SVE BULLETIN

QVM BULLETIN: Q-308R1
Revision date

2021 E-Series DRW Tailpipe Kit – Cutaway / Stripped Chassis

REVISION	UPDATE	REVISION DATE
Q-308	INITIAL RELEASE	03 / APR / 2020
Q-308R1	Add build date restriction	20 / APR / 2020

Figure1: Swage Dimension

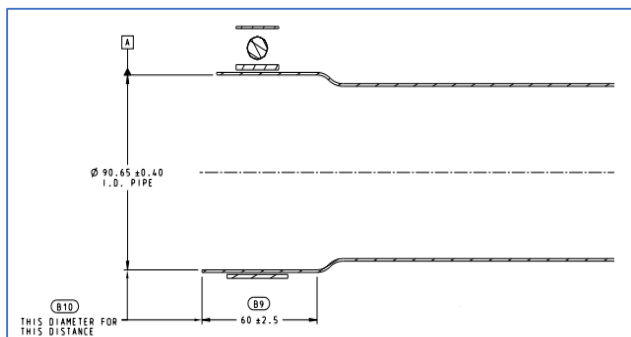
The tailpipe extension kit included in the dunnage box for all incomplete vehicles with gas engines may be too short for some final stage manufacturers applications. A design change is in process to increase the length of the tailpipe to the same length as 2019MY. This bulletin will be updated with the date of when the longer pipe goes into production. This bulletin gives guidance for extending the tailpipe to meet the final stage manufacturers application.

If the straight tailpipe extension pipe included with the vehicle is not long enough for the application a tailpipe provided by the final stage manufacturer may be used. Recommend using the following material:

Pipe Material: ASTM S40900 (AL409) A240, A480, COAT T1-25 A463, 82.55 mm diameter, 1.2 mm wall thickness. Note that a larger diameter pipe may be used, but 82.55 mm diameter is the minimum diameter that can be used.

Per Figure 1, the end of the straight pipe, which attaches to the tailpipe, should be swaged to 90.65 +/- 0.4mm ID to a depth of 60 +/- 2.5 mm. **The extension pipe can be secured with a clamp, F5TZ-5A231-B, which is available through Ford Service or similar type of U-bolt exhaust clamp with a 94 mm I.D.. DO NOT use clamp included with the tailpipe extension kit that came with the vehicle seen in Figure 2. The clamp included with tailpipe extension requires two Z-slots to be machined into the swaged end of the pipe 180 degrees apart for proper retention.**
